Decision Document

Site 7 Cargo Beach Road Landfill
Containerized Hazardous, Toxic, and Radioactive Waste
(CON-HTRW) Project # F10AK096905
Northeast Cape Formerly Used Defense Site (FUDS)
St. Lawrence Island, Alaska

June 2009

Responsiveness Summary
Northeast Cape Site 7 Cargo Beach Road Landfill Proposed Plan dated May 2008

Figure 3. Landfill geophysical survey results (2007).

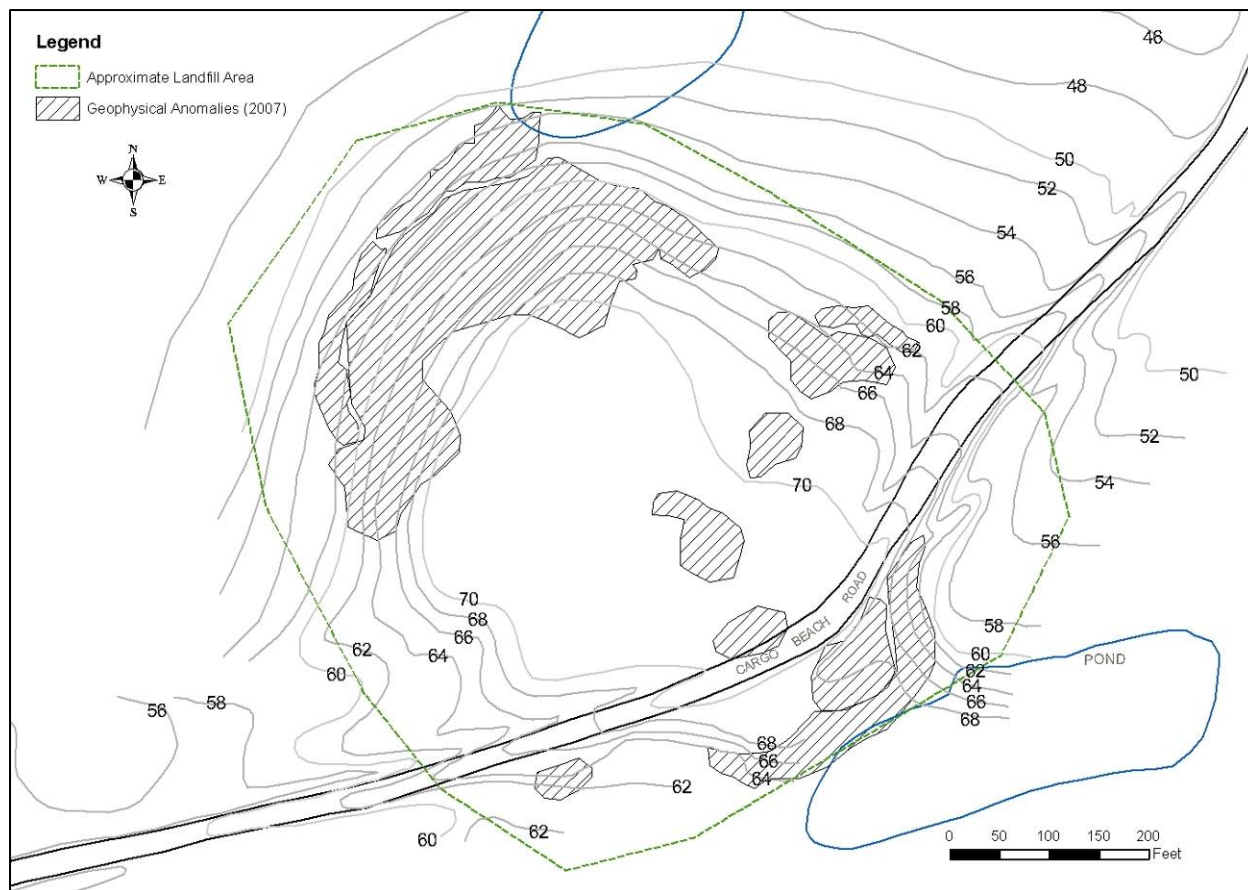
8.	Ron Scudato	June 22, 2008	The geophysical surveys conducted on Site 7 are in general agreement that the elevated mound is comprised of a natural rock core material with waste fill deposited on top and on the slopes of the original rock mound. Based on the material exposed on the mound margins and the discovered partially filled drums of waste material, it is evident the dump was	The purpose of the intrusive investigation is to identify and remove drums with contents. The drum discovered and removed in 2005 contained used oil, and did not contain any hazardous constituents such as PCBs or chlorinated compounds.

Figure 7. Cargo Beach Road Landfill historical sampling locations.

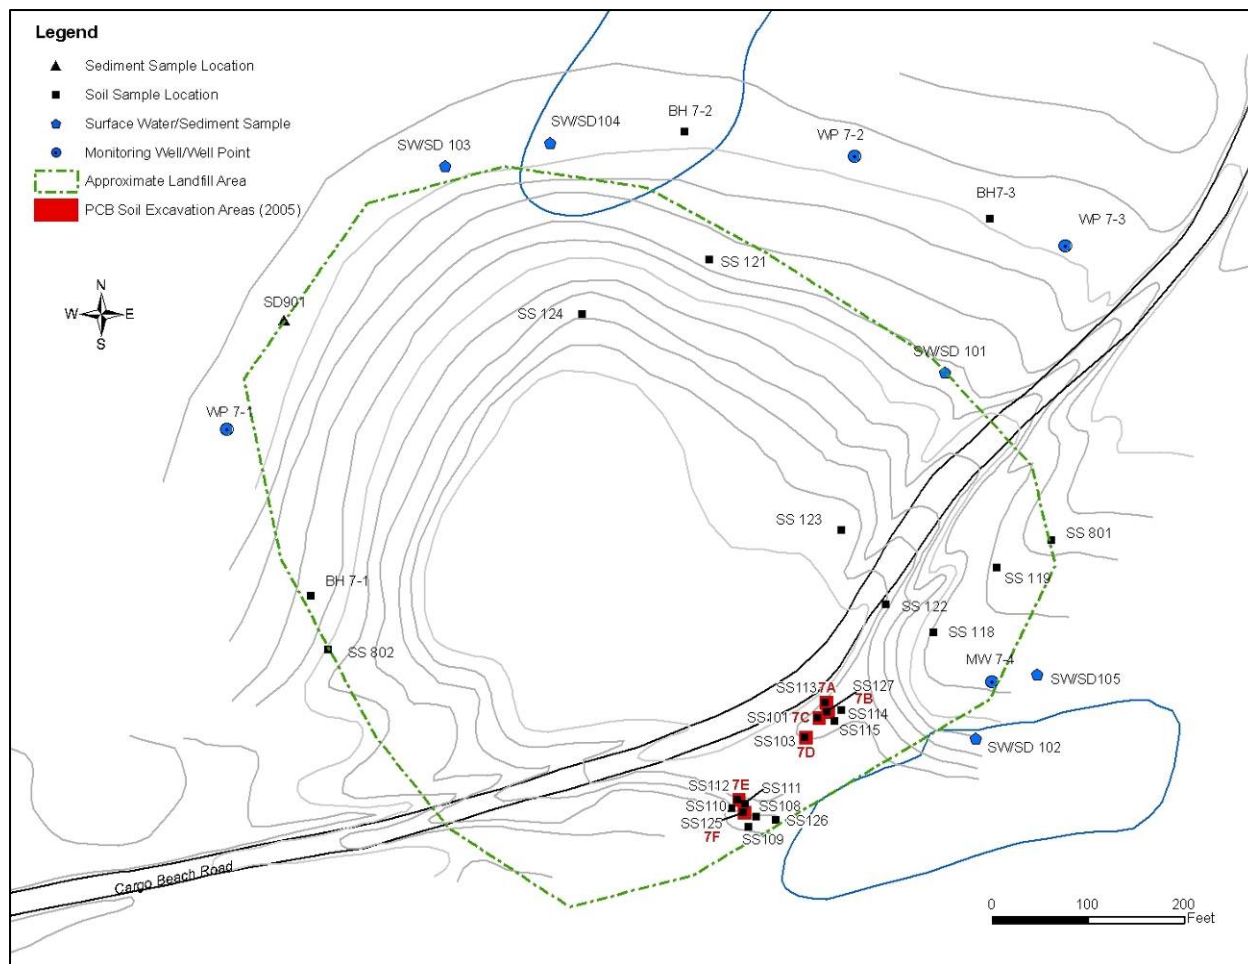
Name	Date	Comment	USACE Response
1.	Ron Scrudato	June 22, 2008	Sampling conducted by USACOE contractors that did not differentiate cap material from material that had been buried in the landfill or was affected by land filled material. The landfill cap is comprised of material deposited on top of the waste. Sampling of the cap is reflective of where the material was excavated and has nothing to do with the composition of the underlying waste.	The primary objective of the remedial investigations was to determine if the landfill contents were migrating away from the mound. The purpose was not to sample within the landfill itself.
